Subject: RE: NYM/2022/003 NYM/2022/004 The Old Farmhouse Throxenby

Please find attached a revised proposed Front and Left elevation drawing showing the revised configuration of window FF8 in line with your suggestion.

Also attached is a revised section drawing showing the proposed vertical sliding windows with cords and weights and pulleys as you have requested.

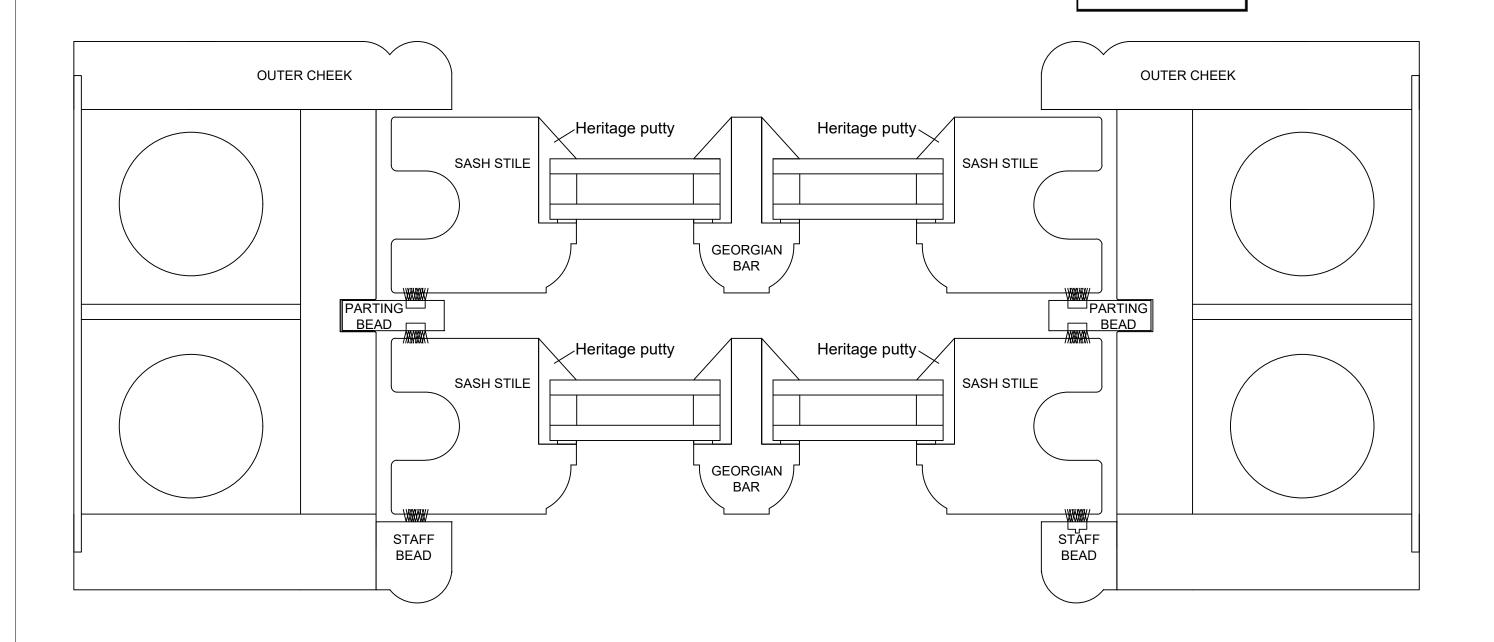
I have now spoken with my colleague regarding the installation of spiral balances at the property. Our stance is one that retains the vertical sliding sash system (retain and make good existing boxes), they are appropriate and contribute to the character of this Listed Building.

Whilst I understand the issue with the increased weight not being compatible, guidance states that when windows historic or later insertions make a positive contribution to the significance of the building, they should be retained. When these windows do not contain historic glass, the use of slim line double glazing can be introduced without causing any harm.

The concern is that the appropriate window system is being removed to accommodate the increased weight when it's the incorporation of double glazing that should accommodate the existing system – the vertical sliding sash system.

Alternative slim line glazing options need to be explored so to accommodate this change whilst retaining the appropriate system, one which contributes to the building and fits within the historical narrative – cords, weights, pulleys etc.

In addition, for the avoidance of doubt, all new sashes, either HSS or VSS will not have the horns replicated. Looking at the proposed item schedule this does seem the case.

Finally I confirm that horns will not be incorporated into any of the proposed vertical or horizontal sliding windows. I trust this now satisfies all of your concerns and that you can now proceed to approve the application without further delay.
